**FEDERAL TRADE COMMISSION**

**Energy and Water Use Labeling for Consumer Products Under the Energy Policy and Conservation Act (Energy Labeling Rule)**

**ACTION:** Final rule.

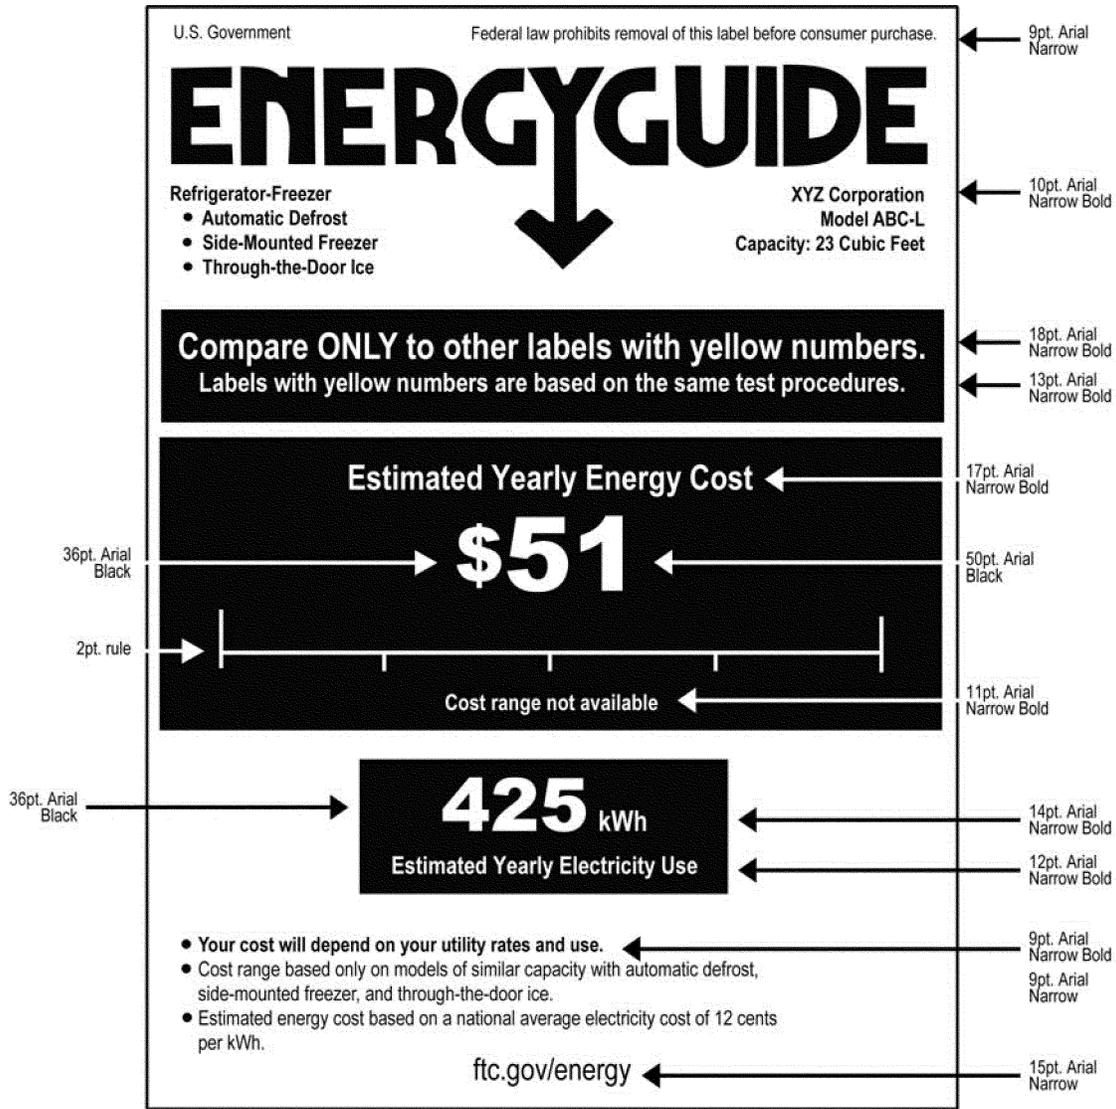
- 5. Appendix L to part 305 is amended as follows:
- a. Prototype Labels 1, 2, 3, and 4 are revised;

- b. Sample Labels 7, 7A, 8, 9, 9A, and 9B are revised;
- c. Sample Labels 7B and 8A are removed; and
- d. Sample Label 17 is added.
